Proposed Project Changes

Ames Pond Trail Maintenance – MA DEP#286-0291

Wendell Rd., Shutesbury, MA

Proposal by Walker Korby (Terramor, LLC) for
Kestrel Land Trust, PO Box 1016, Amherst, MA 01004

Walk-Behind Brush Cutter:

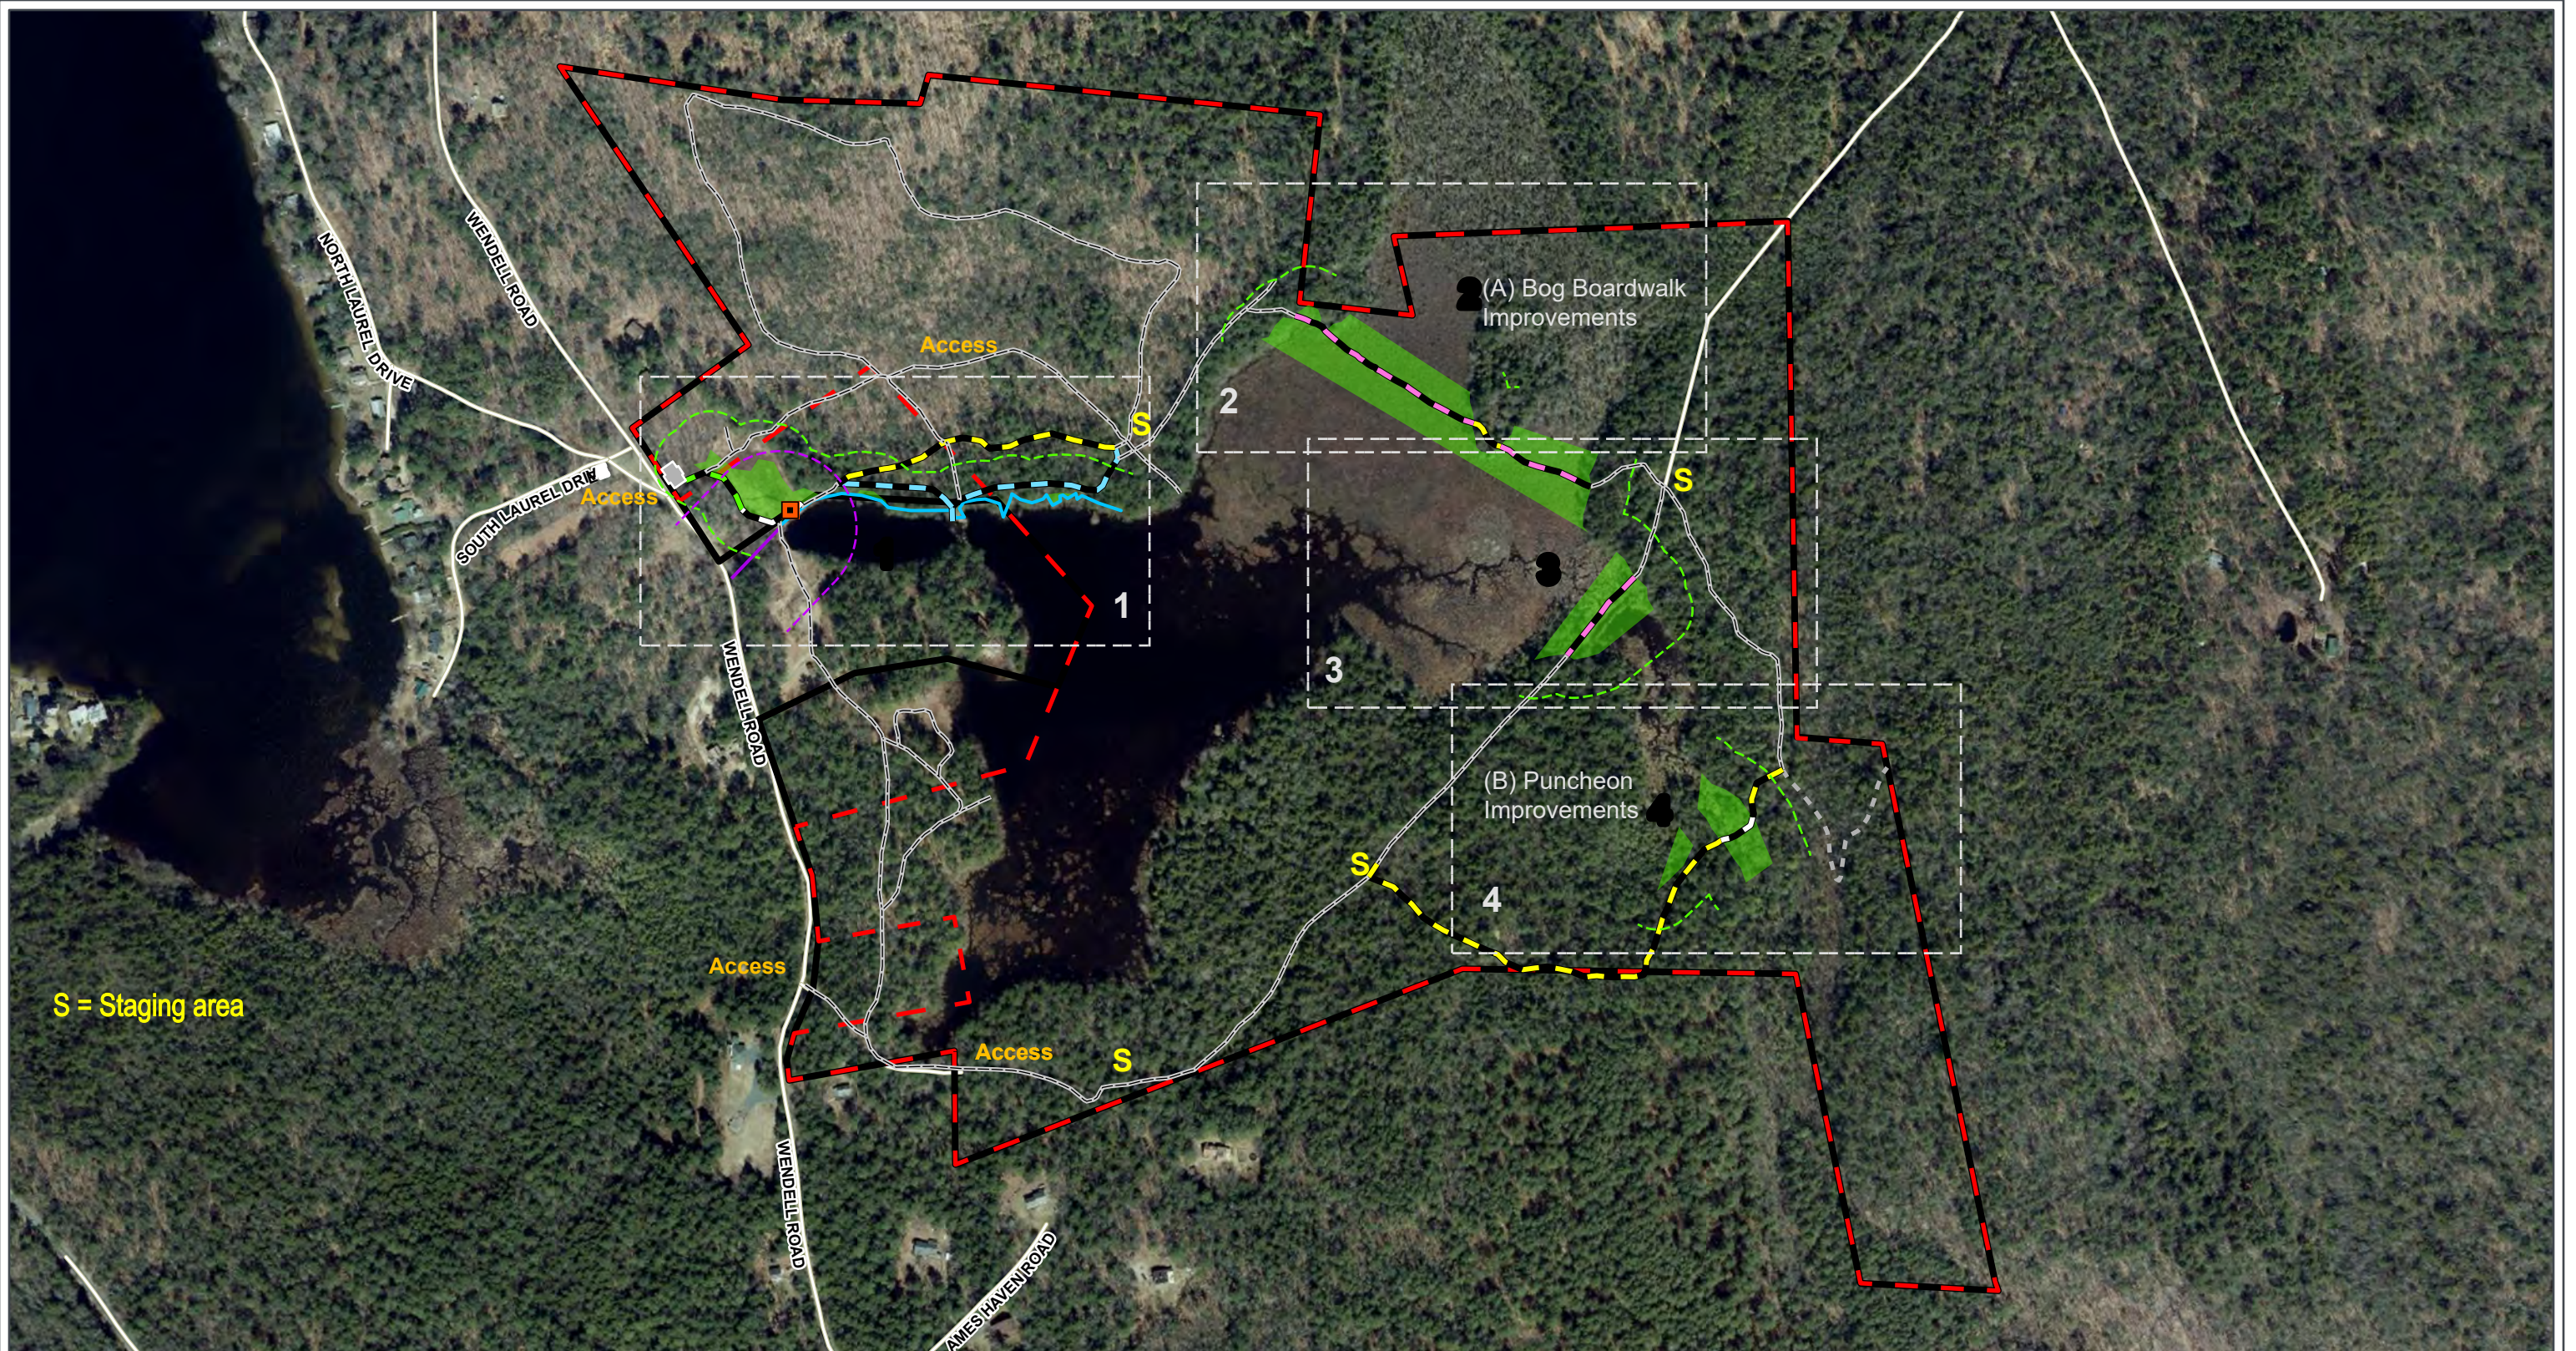
As previously approved, tractor mowing of the A-series BVW shall occur only after the ground is frozen in November or later. Mowing when the ground is NOT frozen may be done using small-scale, walk-behind motorized equipment.

The winter of 2022-2023 has shown us that with the effects of climate change, our region may frequently experience years when the ground remains substantially unfrozen, a condition that inhibits mowing using wheeled tractors. We anticipate that the current special condition allowing mowing only when the ground is frozen will prevent mowing altogether in warmer years, undermining KLT's ability to maintain the current vegetation composition in the meadow. For management flexibility, when conditions prevent mowing with a tractor, we propose to use a DR Power Equipment walk-behind brush cutter (see image below).

The walk-behind brush cutter sits on two powered wheels and has a 34 inch wide cutting deck. Total weight is 340 pounds, considerably less than a tractor/brush cutter combination. We estimate the psi of this machine to be 10-14, standard for lawn mowers.

AMES POND TRAIL RESTORATION
Figure 5. Wetland Delineation
 Map 3 of 4

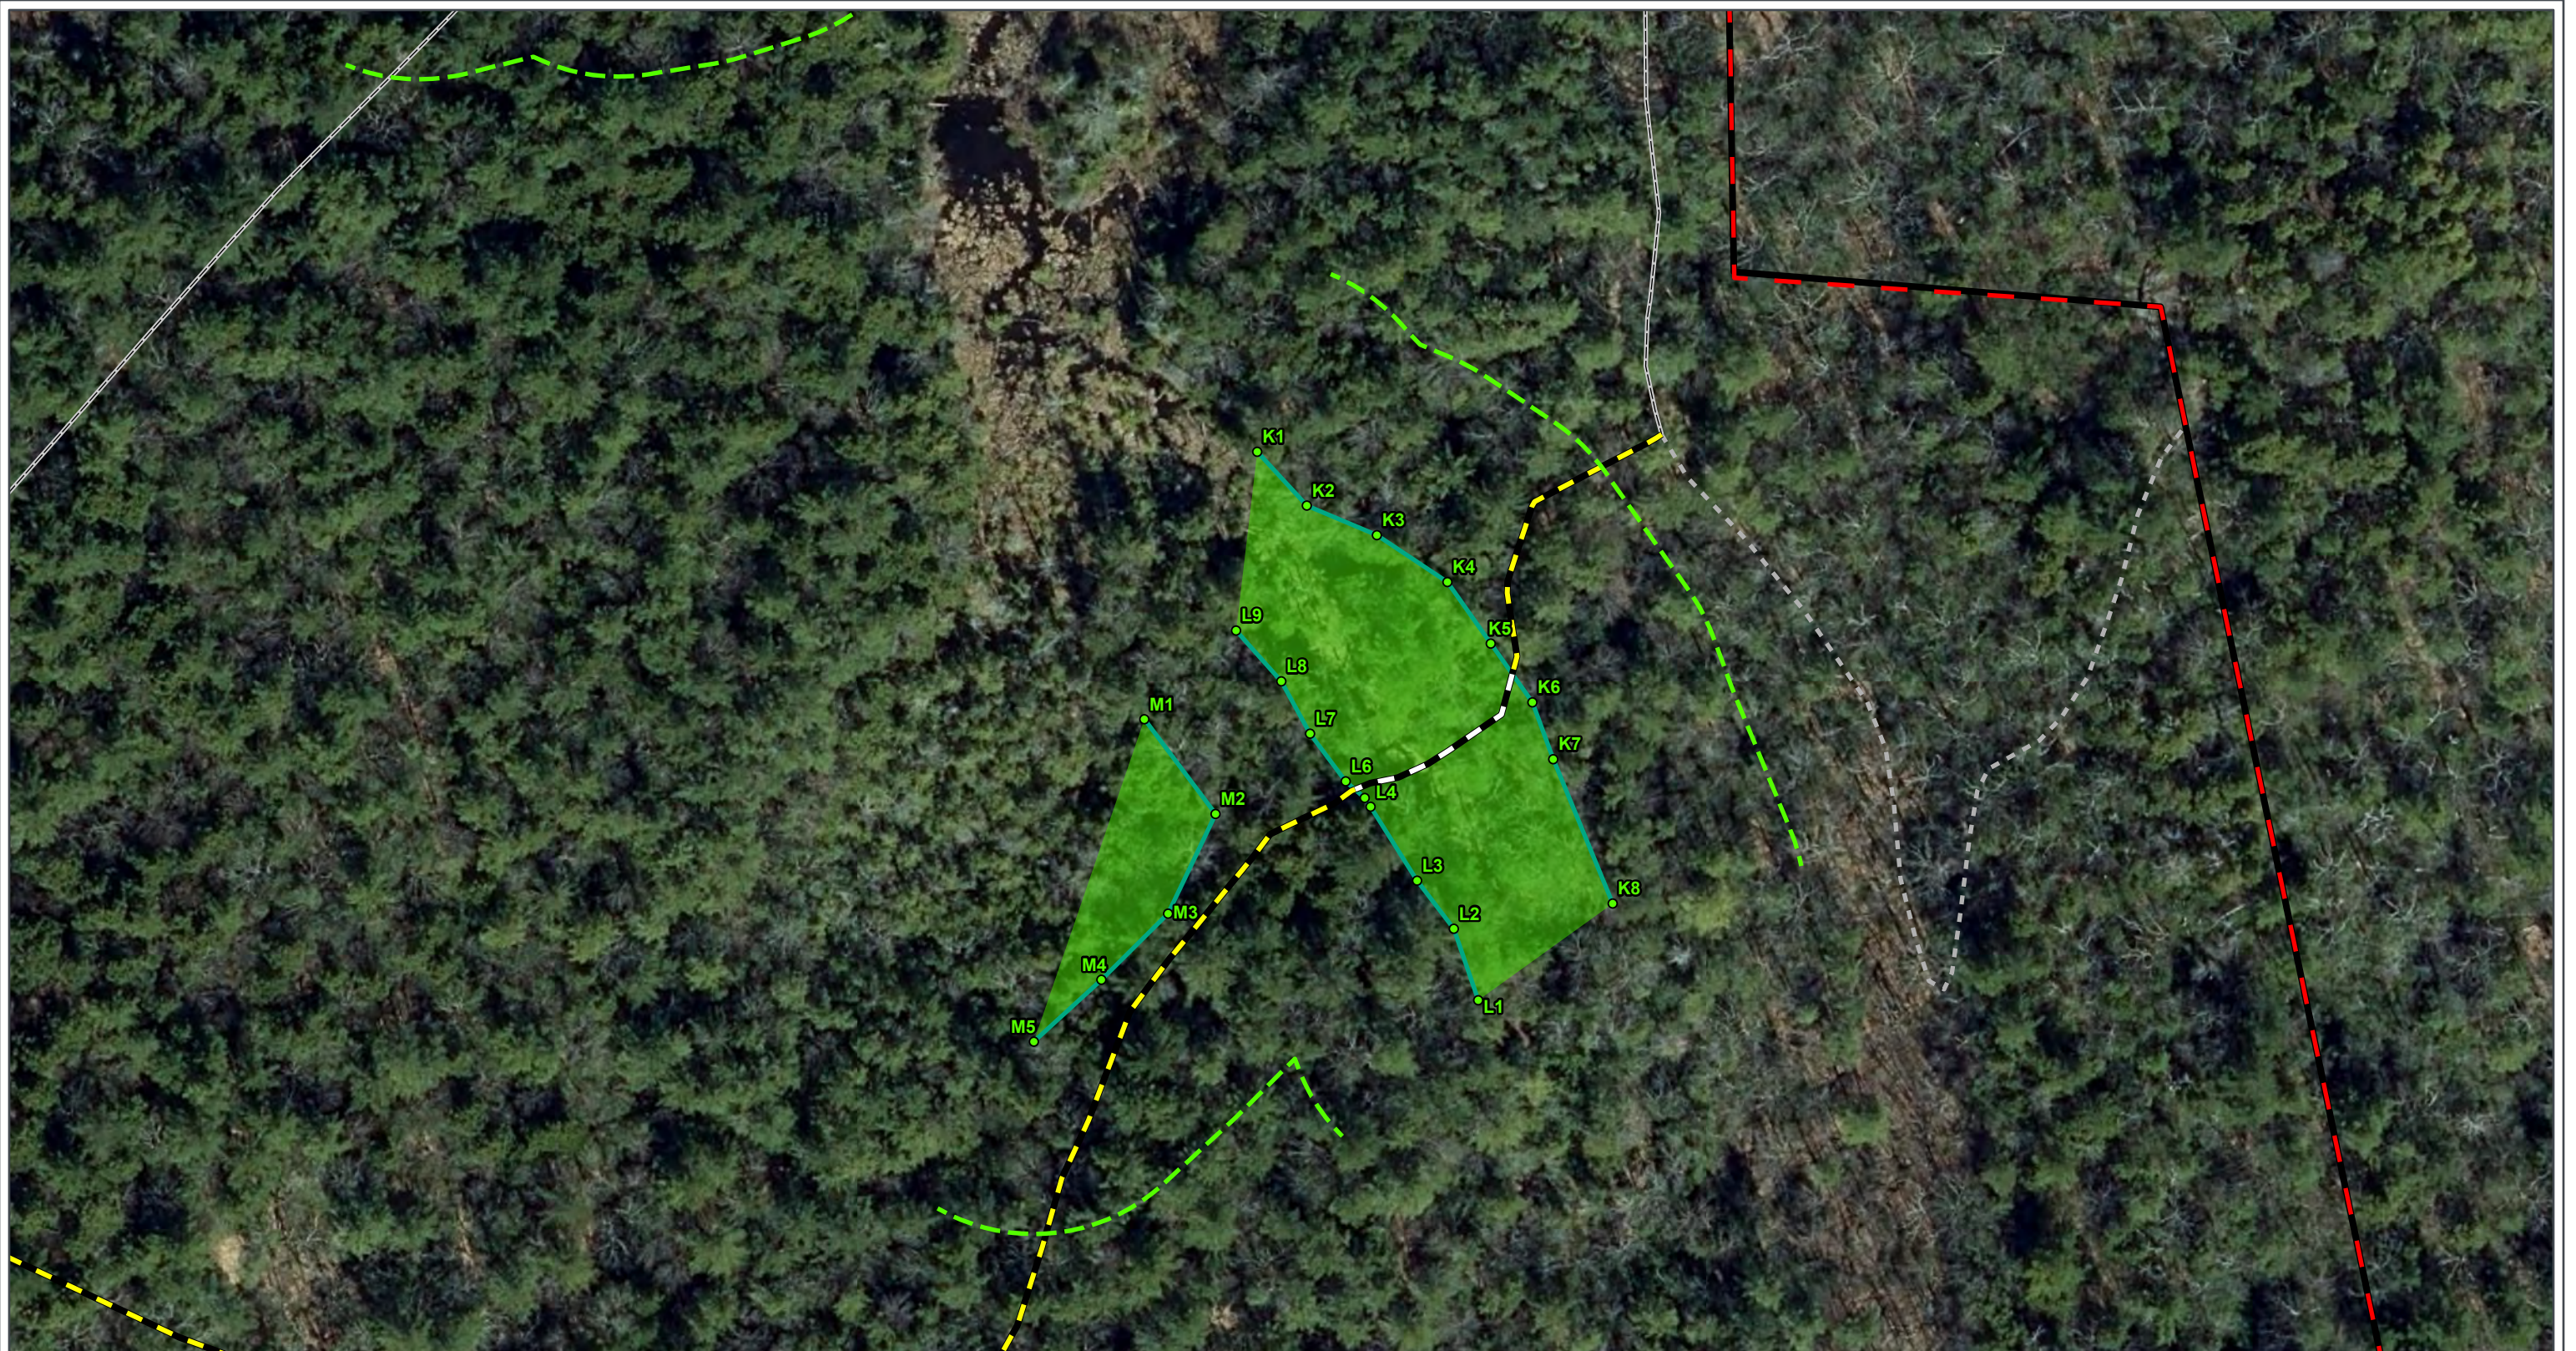
- Within the bog (D, E & F wetlands), replace the existing boardwalk with a boardwalk supported by machine-driven helical piles (see example diagram and technical specs, attached).
- The machine to be refueled at the work site with special precautions.

After extensive site analysis, we have determined that soil type and depth within the bog setting dictates the use of machine-driven helical piles (see Helical Pile Example Diagram, attached). Driving depths to properly penetrate load-bearing soil and ensure a stable supporting structure exceed practical limitations of hand-driven supporting systems. Site soil strength observations suggest that driving depths will be a minimum of 5 ft. and could exceed 10 ft.

The helical piles, or screw piles, will be installed using a tracked hydraulic machine no wider than 39 inches, and no heavier than 4,000 lbs. The machine will be supported by 5x8 ft., temporary aluminum deck sections resting on the current boardwalk, acting as marsh mats. The existing boardwalk width of 1.5 ft. will support at least half the weight of the temporary deck sections and substantially reduce overall site impact. The supporting temporary deck sections will distribute the weight of the machine and workers for an impact of less than 1.5 lbs. psi (per square inch). (Adult humans have a foot pressure between 2.5-3.5 lbs psi.)

Piles are installed in pairs, spaced 36 inches apart. Sets will be installed every 11 ft., for a total of approx. 180 pile locations. Due to the unstable upper bog soils (more than 5 ft. thick in areas), piles may need to be driven more than 10 ft. deep to properly penetrate load-bearing soil. Cross-bracing within the structure may be necessary for lateral support. If required, additional piles will be installed at strategic locations. See technical spec for Mascore Helical Pile (attached).

Figure 15.31 - Diamond Pier DP-50 Model

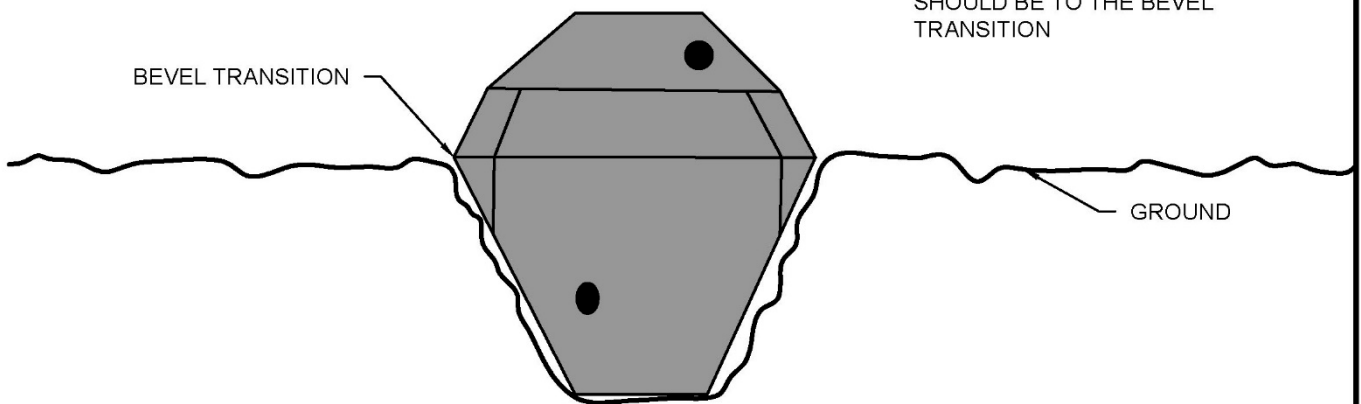
- Within the forested wetlands (K & L-wetlands), replace the entire puncheon with a boardwalk supported by specialized diamond piers, which are installed using battery operated or electric hand-held equipment (see example diagram, attached).
- Extend puncheon length by 60 linear ft. (approx. 30 ft added to each end), and reduce the width from 4 to 3 ft.

After additional site analysis, we have determined that the current puncheon structure does not fully span the existing wetland, falling short on either end by 30 linear feet. Additionally, the current structure is of unknown age (assumed older than 20 years), raising concerns about its longevity even with the proposed repairs. We propose that the best course of action is to fully replace the puncheon with a boardwalk in conjunction with the other planned boardwalk improvements. The boardwalk will be supported by diamond piers (see Diamond Pier Example Diagram, attached).

The new structure will be constructed on the current puncheon footprint. Diamond piers are specialized precast concrete blocks that are secured by four galvanized steel rods driven into the soil. They perform well in soil that is sandy or has a high amount of clay, silt, or water. The four pins driven through the pier and into the ground provide a large support base for the pier, so that the weight of the boardwalk is supported by a much larger area than just the footprint of the pier. The angles of the rods counteract the freezing and thawing forces, allowing for the concrete blocks to be installed with only 10-12 inches of hand digging for each pier, minimizing construction impacts. The rods will be driven with battery operated or electric hand-held equipment.
